Regular Meeting
Design Review Board
February 18, 2016
7:00 p.m.

AGENDA
TIBURON DESIGN REVIEW BOARD

STAFF REPORT

To: Members of the Design Review Board
From: Planning Manager Watrous
Subject: 2225 Vistazo East Street; File Nos. VAR2015022/DR2015145; Site Plan and Architecture Review for Construction of a New Single-Family Dwelling, with a Variance for Excess Lot Coverage
Reviewed By: _____

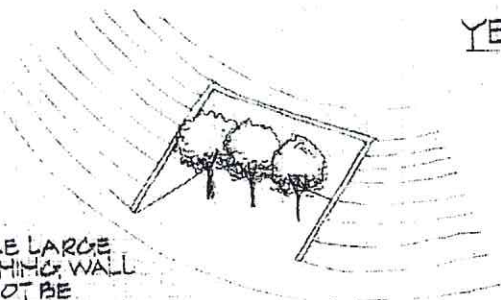
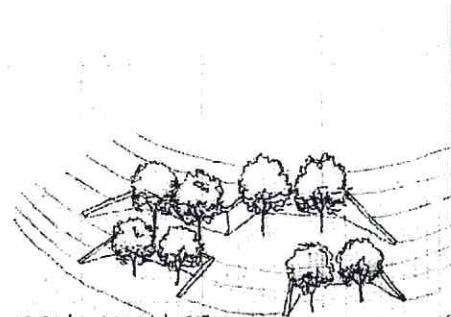
Goal 1, Principle 7 of the Hillside Design Guidelines states that *"Avoid large retaining walls in a uniform plane. Break retaining walls into elements, terraces."* New retaining walls would be situated at the pool deck and terrace downwards on the hillside. New landscaping would be planted between the walls to provide screening and reduce any bulk from the new walls. In addition, the landscaping would soften the walls and help blend the walls into the hillside.

- SINGLE LARGE RETAINING WALL CANNOT BE SCREENED EASILY.

- SINGLE RETAINING WALL MAKES A MASSIVE SCAR ON HILLSIDE, TOE OF WALL PRECLUDES PLANTING OF EFFECTIVE SCREEN.

- SEVERAL SMALLER RETAINING WALLS CAN BE SCREENED.
